Access Compliance Report

Public Rights-of-Way (Curb Ramps)

Intersection ID: 29425	Main Street: BRADSTREET COMMONS WY	Cross Street: NOVELLA DR	Location:	W
ADA ID: 3C0105C8E6EB	Ramp Type: Perp	Initial Pass/Fail: Fail	Overall Compliance: No	Severity Score: 12.5
Codes/Mitigation Info/Possible Solution		Field Measurements/Component Compliance

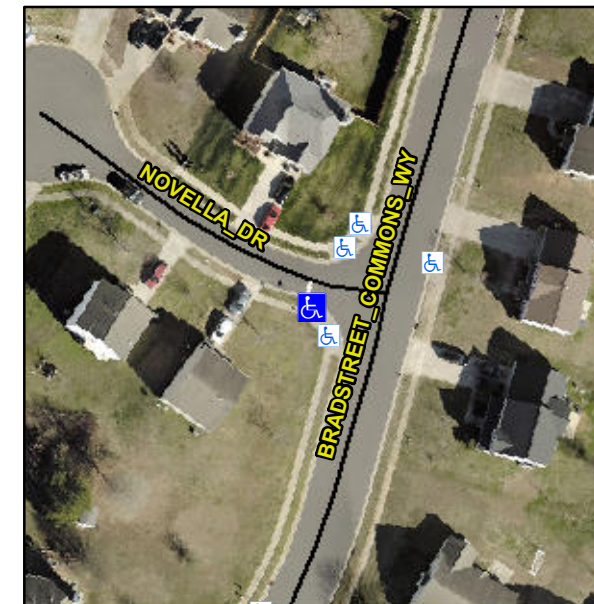
Not Found, R304.2.2

Compliance	Description	Data	Compliance	Description	Data
N/A	Ramp Length (in)	49.5	No	Ramp Slope (%)	8.6
Yes	Ramp Width (in)	48.0	Yes	Ramp XSlope (%)	0.3
N/A	Flare Type LT	N/A	N/A	Flare Type RT	N/A
N/A	Flare Slope LT (%)	N/A	N/A	Flare Slope RT (%)	N/A
N/A	Flare Traversable LT?	N/A	N/A	Flare Traversable RT?	N/A
N/A	Landing Length (in)	N/A	N/A	DWS Provided?	N/A
N/A	Landing Width (in)	N/A	N/A	DWS Contrast?	N/A
N/A	Landing Slope (%)	N/A	N/A	DWS Length (in)	N/A
N/A	Landing X Slope (%)	N/A	N/A	DWS Full Width?	N/A
N/A	Landing Curb? (Y/N)	N/A	N/A	DWS Offset (in)	N/A
N/A	Shared Landing?	N/A			
N/A	Gutter Ponding?	N/A	N/A	Gutter Slope (%)	N/A
N/A	Gutter Lip Ht (in)	N/A	N/A	Gutter X Slope (%)	N/A
N/A	Painted X Walk1?	No	N/A	Painted X Walk2?	N/A
	X Walk 1 Direction	To NE		X Walk 2 Direction	N/A
N/A	X Walk 1 Width (in)	N/A	N/A	X Walk 2 Width (in)	N/A
	X Walk 1 Slope (%)	5.9		X Walk 2 Slope (%)	N/A
	X Walk 1 X Slope (%)	2.6		X Walk 2 X Slope (%)	N/A

Remove & Replace Entire Ramp.
